FINAL DECISION
Powercor distribution
determination
2016 to 2020

Attachment 6 – Capital
expenditure

May 2016

Figure 6.6 Powercor total capex—historical and forecast for 2001–2020

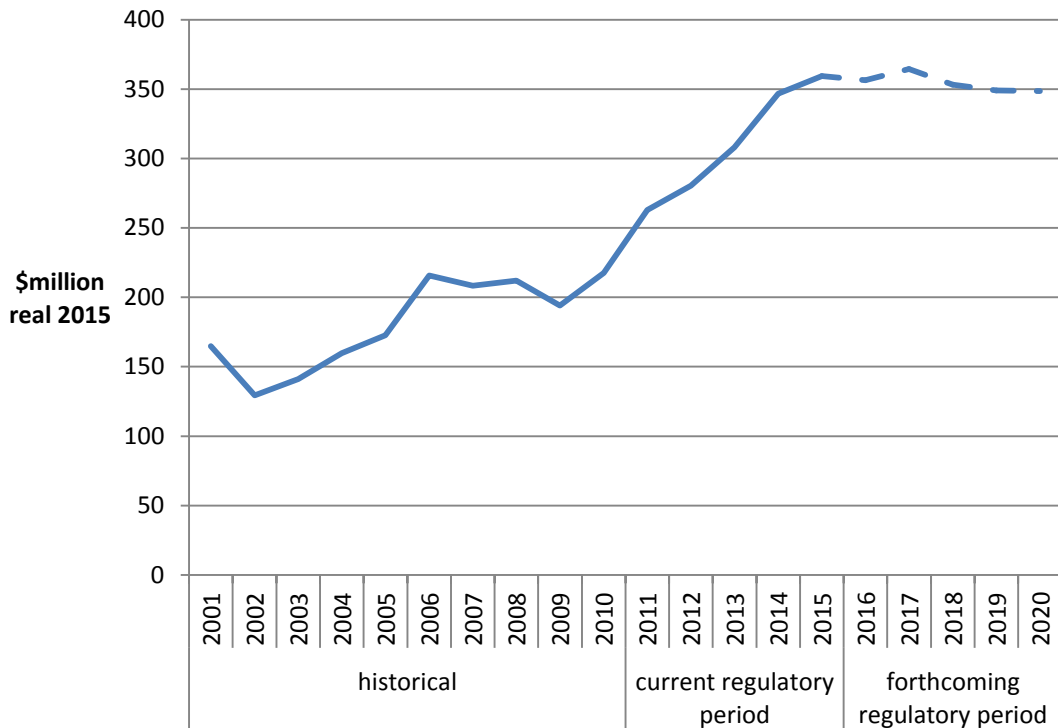
Figure 6.6 shows actual historical capex and proposed capex between 2001 and 2020. This figure shows that Powercor’s revised proposal forecast is significantly higher than historical levels (actual spend).

Figure 6.7 Powercor’s demand-driven capex historic actual and proposed for 2016–20 period (\$2015, million, excluding overheads)

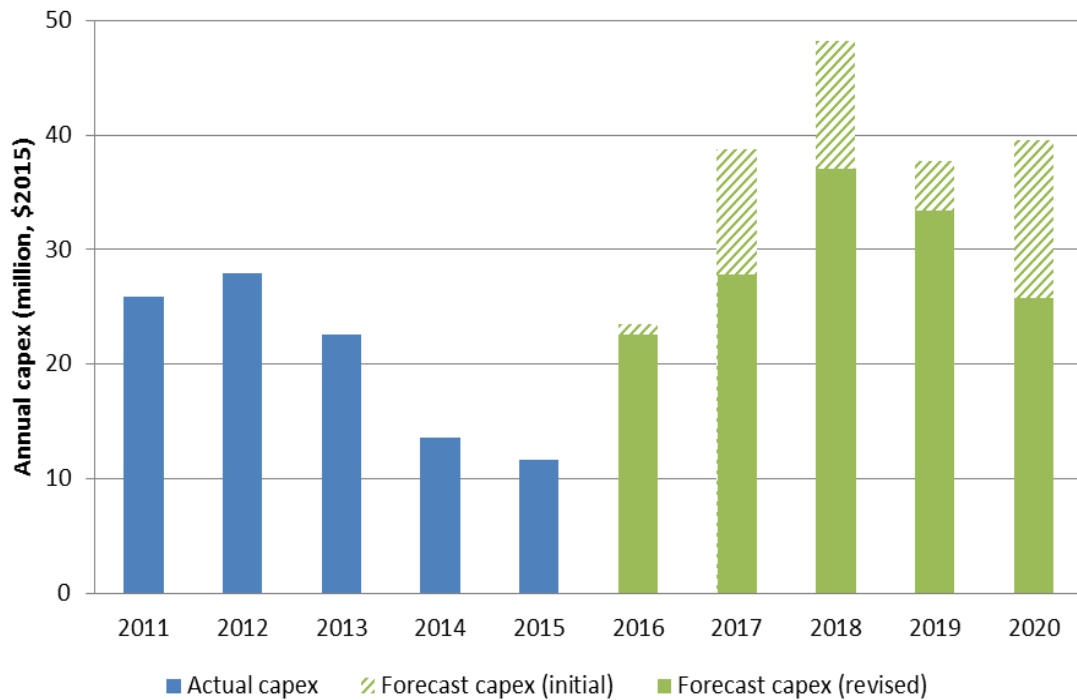
Figure 6.7 shows Powercor's forecast demand-augex compared to its actual demand augex over the 2011-15 period, including the changes between the initial and revised proposals. Powercor's initial proposal included a demand-augex forecast that was double its actual demand-augex over the 2011-15 period. However, in response to our preliminary decision, Powercor reduced its proposed augex and now proposes an increase of approximately 50 per cent compared to 2011–15.

In turn, Powercor has reduced its forecast demand-augex by 25 per cent (as shown in Figure 6.7). This reduction in demand augex in response to reduced and realistic maximum demand forecasts gives us greater confidence in Powercor's forecast capex. However, to examine the impact of revised maximum demand forecasts on the need

Figure 6.8 Powercor zone substation utilisation 2010 to 2020 (without augmentation)

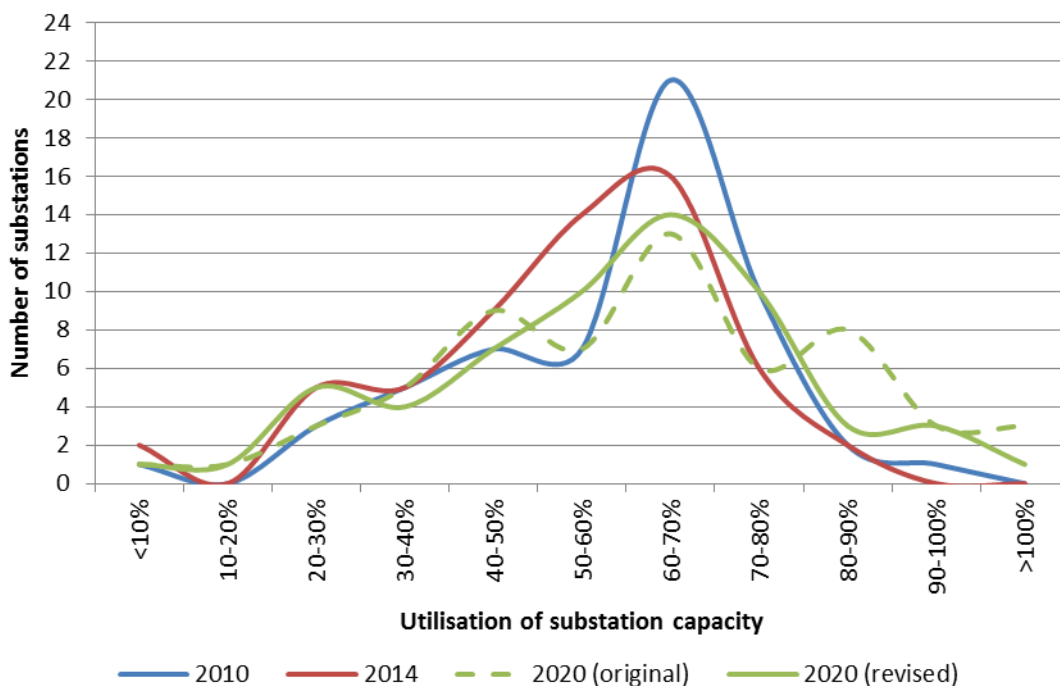
Figure 6.8 shows Powercor's network utilisation (at the zone substation level) between 2010 and 2020. It shows that Powercor experienced a decline in overall network utilisation between 2010 and 2014 due to augmentation and a flattening of demand (shown by a shift to the left in network utilisation by 2014, the red line). In contrast to the most recent years, Powercor expected that network utilization will increase overall by 2020, with more zone substations forecast to operate above 60 per cent capacity and an increase in highly utilised zone substations.

As further shown in Figure 6.8, Powercor's revised demand forecasts means that it expects that less of its zone substations will be highly utilised by 2020 (shown by the difference between the two green lines). This decrease in forecast network utilisation indicates that there are fewer capacity constraints on the network. Nonetheless, the remaining number of highly utilised substations suggests that there still some capacity constraints on the network.

Figure 6.9 Powercor's historic LV augex (\$2015) and raw maximum demand between 2009 and 2015

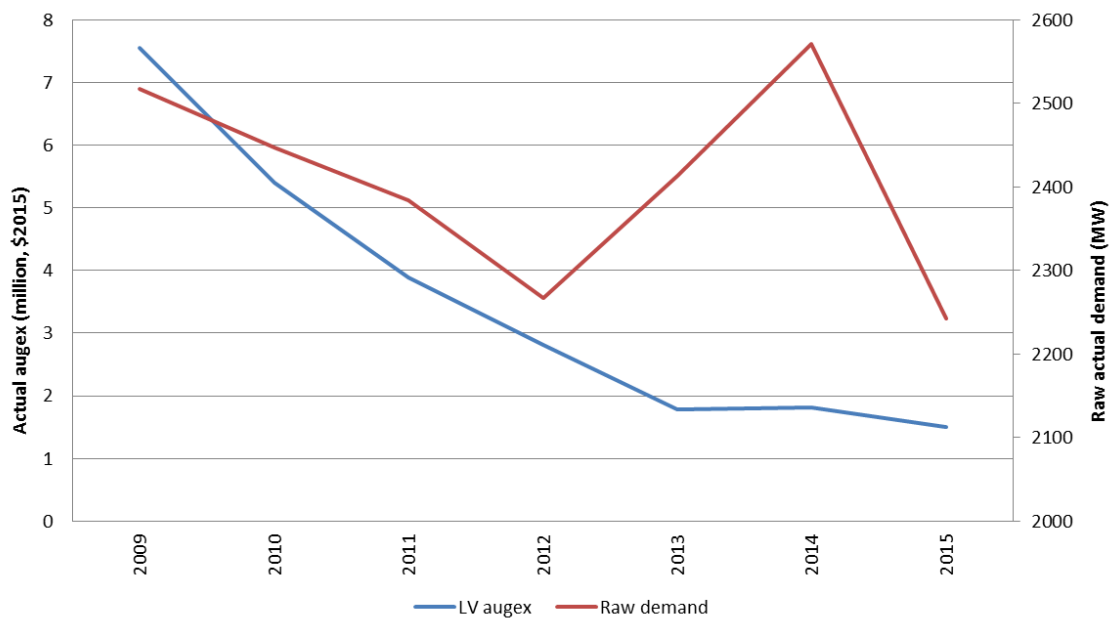
In our preliminary decision, we accepted the use of historical trend for this capex but disagreed with Powercor's use of the 2009-15 averaging period. As shown in Figure 6.9 below, Powercor's historical augex on LV feeders has been trending downwards consistently between 2009 and 2015. We considered that an averaging process that picks up two high years in 2009 and 2010 may tend to bias the capex forecast upward.

Figure 6.9 compares Powercor's historical LV augex against its historical raw maximum demand over the 2009-15 period.¹⁰⁶ Because hot weather is generally reflected in an increase in maximum demand (for example, due to higher use and installation of air conditioners), we would expect to see a correlation between rises in Powercor's maximum demand and augex on its low voltage network. Instead, this data shows that Powercor experienced a rise in maximum demand in both 2013 and 2014 and yet it did not incur any additional augex on its low voltage network.

Figure 6.10 Powercor - Actual and revised forecast repex (\$ million, 2015)

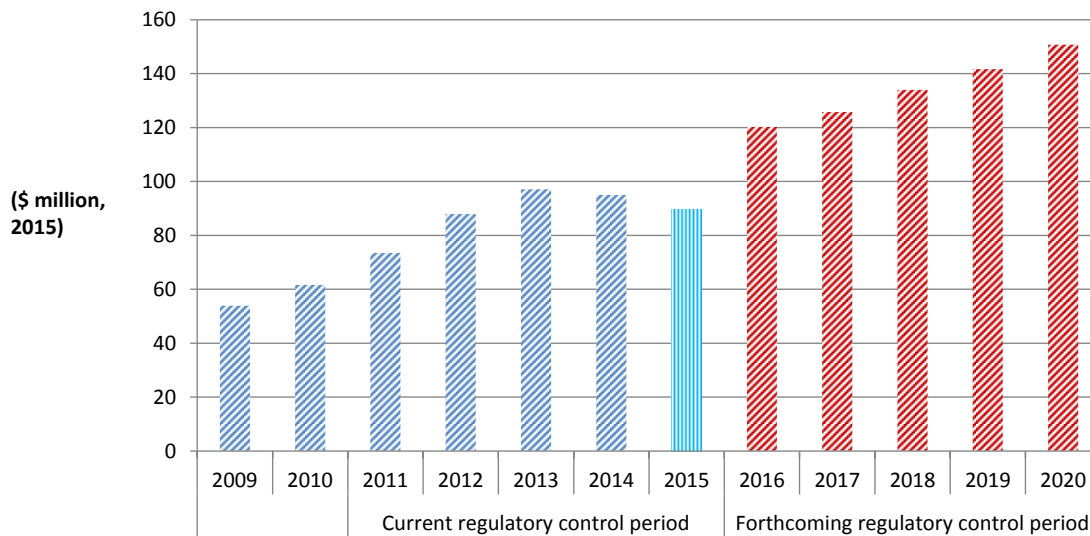
We have conducted a trend analysis of repex. The NER requires that we consider the actual and expected capital expenditure during any preceding regulatory control period. Our use of trend analysis is to gauge how Powercor’s historical actual repex compares to its expected repex for the 2016–20 regulatory control period. Figure 6.10 shows Powercor’s repex spend has been trending up with the exception of 2014 and 2015.

Figure 6.11 Maximum system demand (Non-coincident, 10% PoE, MW)

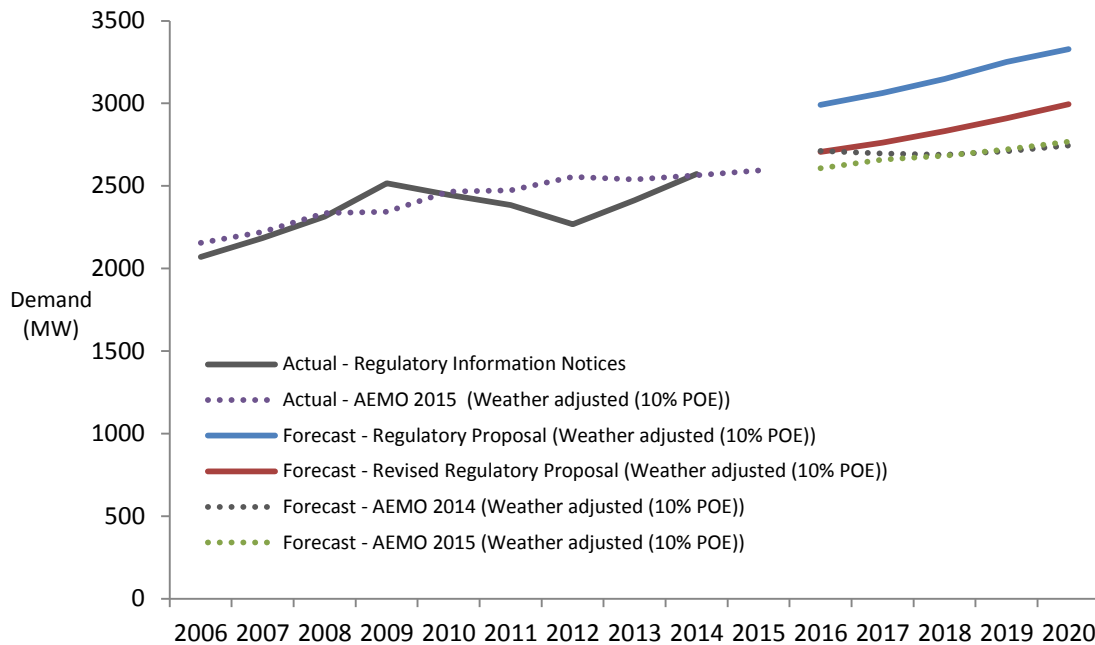
Figure 6.11 and Table 6.18 shows Powercor's revised maximum demand forecast for each year of the 2016–20 regulatory control period. Powercor's revised forecast is generally consistent with growth in maximum demand between 2006 and 2015, using weather adjusted historical demand. Figure 6.11 and Table 6.18 also provides AEMO's latest system demand forecast for its network (the 2015 connection point forecasts), which shows that Powercor forecasts maximum demand to grow at a slightly faster rate than AEMO.
